Mining Remediation
Level 5 Centerpoint Building
Smith Street
Darwin NT 0801

23 September 2019

Variation to the Rehabilitation of the Former Rum Jungle Mine Site Notice of Intent – request for consideration under Clause 14A of the Northern Territory *Environmental Assessment Administrative Procedures*

Figure 1: Overview and Key Features

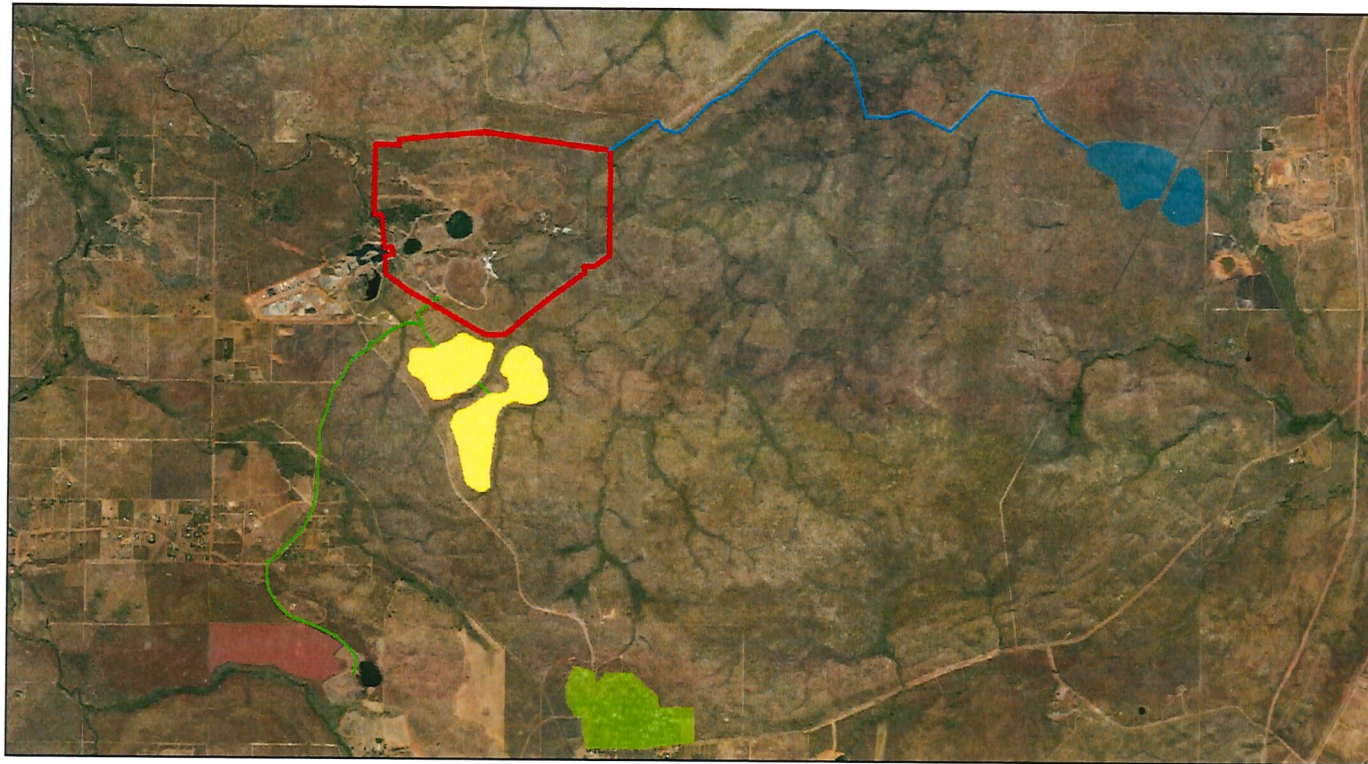
Figure 1 below provides an overview of key features of the proposed concept rehabilitation strategy, including previous borrow and haul road locations.

Figure 2: Main Pit Tailings Cap Methodology

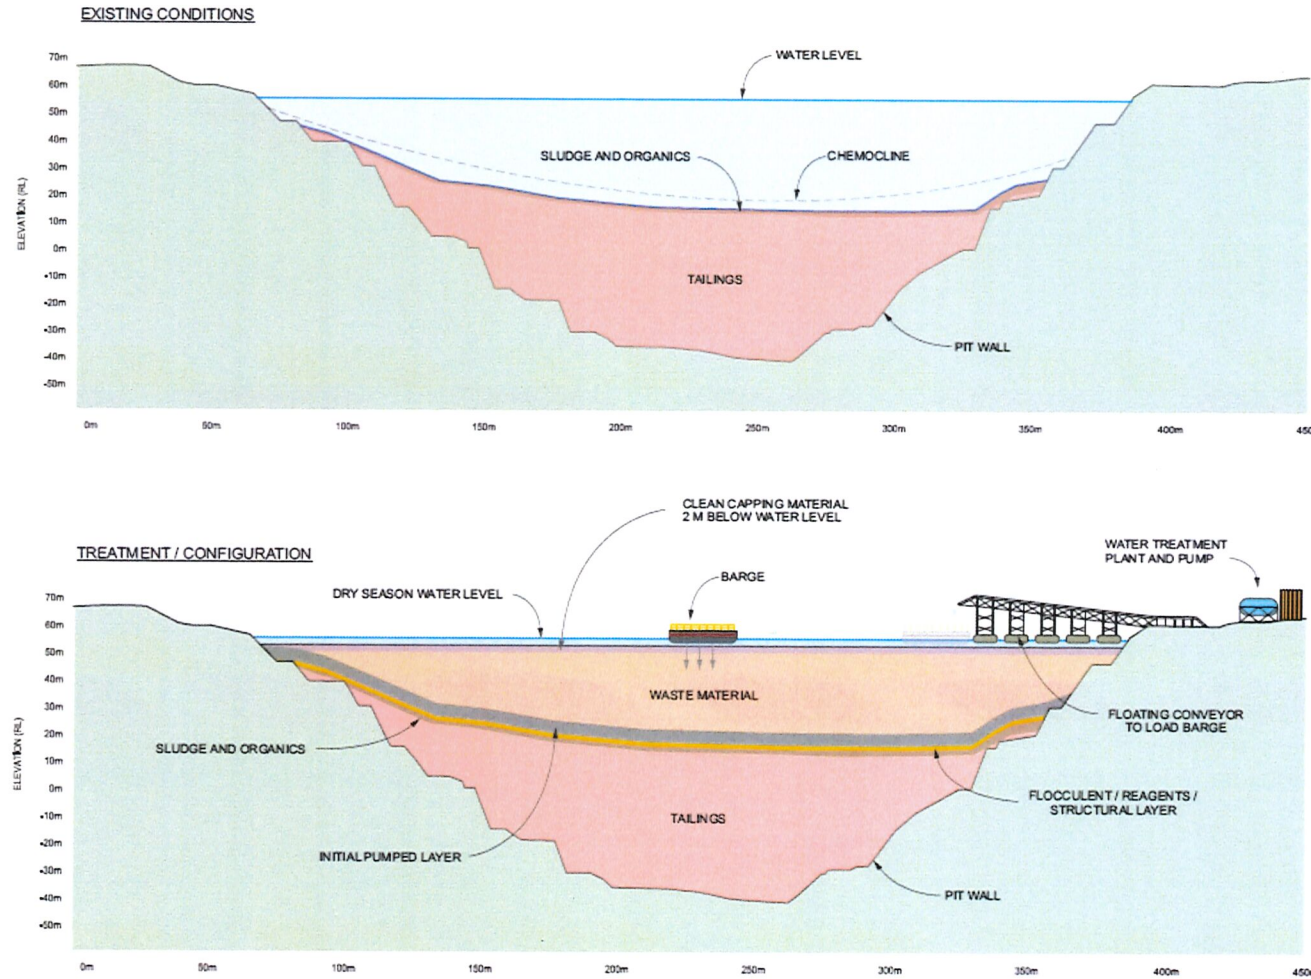
- Figure 2: Two cross-sections of Main Pit are provided on this figure. The first provides an indication of the current state of Main Pit while the second provides details on how the tailings capping will be sub-aqueously placed. Notes are included to provide additional details.
- Figure 3: Central WSF footprints.
- Figure 4: Geology map of the former Rum Jungle Mine site, including proposed location of the Central WSF.
- Figure 5: Plan overview of works associated with Main Pit, including haul roads. Photograph examples of key plant and facilities are also included
